REMARKS

The Office Action issued May 7, 2007 has been received and its contents have been carefully considered.

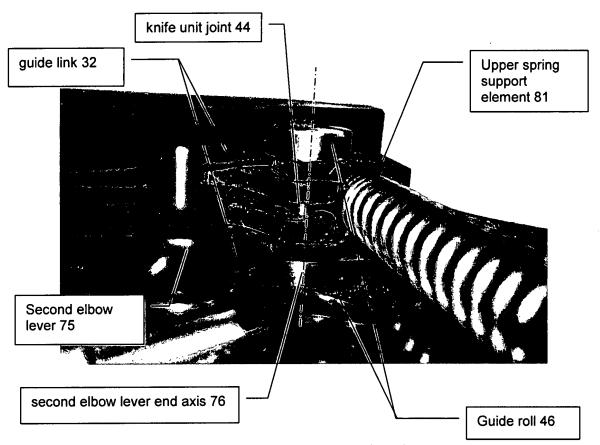
Referring to the objection of the drawings (fig. 1) in paragraph 9 of the Office Action:

Examiner states that the guide roll 49 would overlap the second elbwo lever 75 which would not appear to be possible. In fact the guide roll 46 can have a position situated above the lever 75 as shown in the plane view of figure 1 where it is partially overlapping because it is situated in another plane than the second elbow lever.

The following photograph shows a portion of a wire stripper designed according to the invention. The upper spring support element 81 is U-shaped and has one guide roll 46 on either side, each of them being in contact with one of two rims forming the guide link 32.

The knife unit joint 44 consists of two projections spaced apart from each other, so that the lever 75 which is a flat element can enter the slit between the projections and that the guide roll 46 can be positioned above the lever 75 as shown in figure 1 and the following photograph:
